Item Name: Crosstube Turning Detail

Draw Nbr	Revision Nbr
D212-664-241	Rev D

DART AEROSPACE LTD	Work Order:	99236
Description: Crosstube Assembly (205/212 High Aft)	Part Number:	D212-664-241
Inspection Dwg: D212-664-241 Rev: D		Page 1 of 2

DRAWING NO. D212-664-241	TITLE CROSSTUBE ASSY (205/212 HI AFT)	REV. D	DART AEROSPACE LTD ENGINEERING ORDER		D.E.O. NO. D212-664-241-D-1	SHEET NO. SHEET 1 OF 2	SCALE NTS
DRAWN	CHECKED	MFG. APPR.	APPROVED	DE APPR.			
DATE 11.04.07	DATE 11.04.11	DATE 11.04.12	DATE 11/04/12	DATE 11.04.12

**D212-664-241/-241B
ASSEMBLY DETAIL**

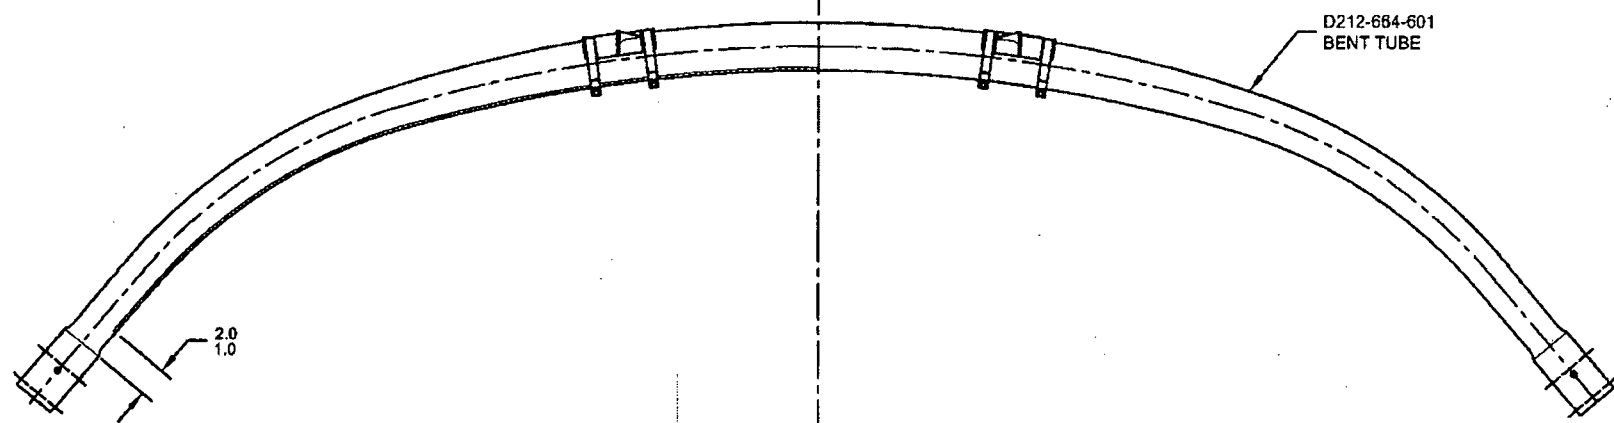
ADD AN INSPECTION WINDOW TO UNDERSIDE OF CROSSTUBE.

NOTES 2 OF SHEET 1 IS AMENDED AS FOLLOWS:

- 2) FINISH: CHEMICAL CONVERSION COAT PER DART QSI 005 4.1
PRIME INSIDE AND OUTSIDE PER DART QSI 005 4.2
MASK UNDERSIDE OF CROSSTUBE AS SHOWN (HATCHED AREA) AND
PAINT OUTSIDE PER DART QSI 005 4.2
REMOVE MASKING AND APPLY CLEAR COAT

- 2) FINISH: CHEMICAL CONVERSION COAT PER DART QSI 005 4.1
PRIME INSIDE AND OUTSIDE PER DART QSI 005 4.2
PAINT OUTSIDE PER DART QSI 005 4.2

MASK AREA PRIOR TO PAINTING,
REMOVE MASKING AFTER PAINT
AND APPLY CLEAR COAT
